PLANNING DEPARTMENT
Staff Report & Recommendation

Design Review Board

SUBJECT: DRB21-0739
291 Palm Avenue

An application has been filed requesting Design Review approval for the construction of a new two-story residence on the east side of the property, one or more waivers and variances from the maximum lot coverage and unit size, from the setback requirements (front & interior sides), from the maximum yard elevation, and from the setback requirements for a roof deck, for the construction of new home, pool, and pool deck, to replace the portion of an existing one-story residence on lot 55.

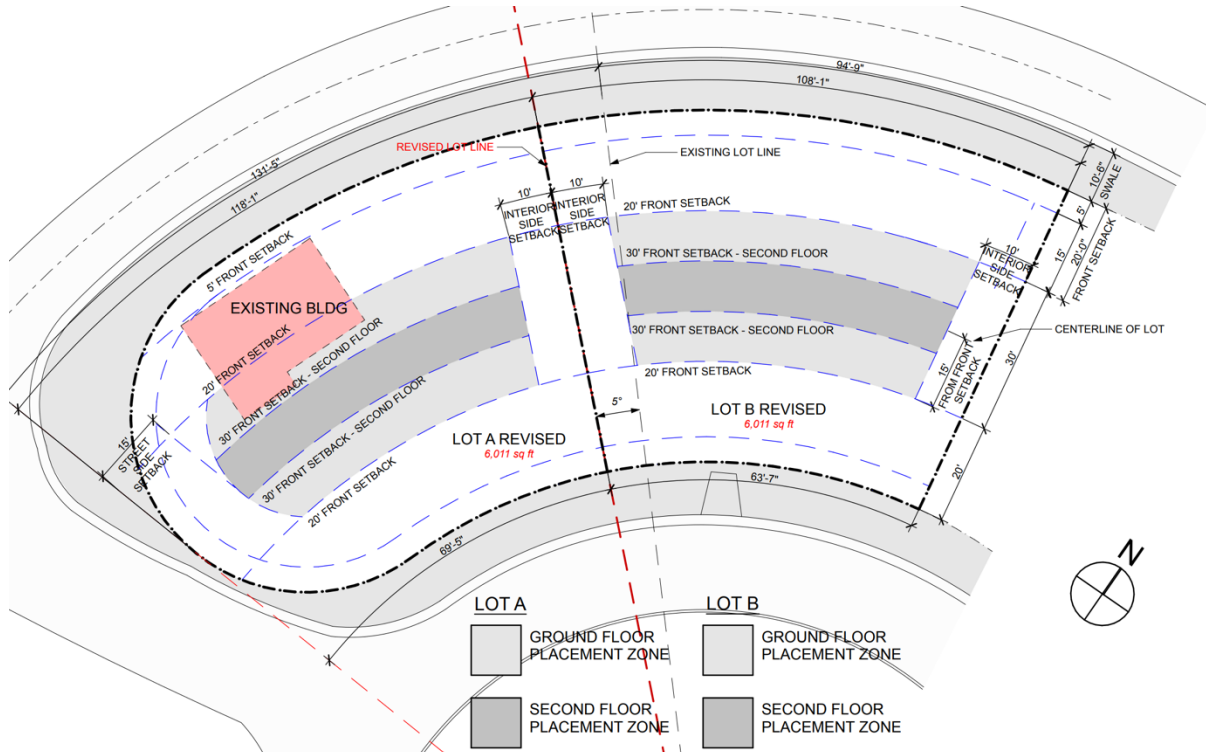
As indicated previously, this lot is rather unique in that it has a curved trapezoidal shape, with two street fronts and is also very shallow, with a lot depth of only 70 feet. Most single family lots on Miami Beach have a lot depth of at least 100 feet. The diagram below shows that absent any relief from the City code, with the current required setbacks, the maximum width of a single-story home is 30 feet, and the maximum width for a 2-story home is only 10 feet. This shallow lot depth, as well as the unique bean shape of the lot, does present a hardship for the construction of any home on the subject site.

The subject property is located on the eastern half of an approved lot split application by the Planning Board. Since the newly created lots do not follow the lines of the original platted lots, the Code limits the maximum lot coverage for a new two-story home to no more than 25% of the lot area, and the maximum unit size shall not exceed 40% of the lot area, or such lesser number, as determined by the planning board. These reduced allowances are intended to mitigate adverse impacts of what could otherwise be a large home on the current site with a unit size up to 50% and footprint of 30%.

Staff would note that the existing homes average unit size (for the study area, included in the Planning Board report) is much larger than the average for most of the City's single family neighborhoods, which is typically around 31%. As such, staff is supportive of the updated variance requests for lot coverage and unit size.
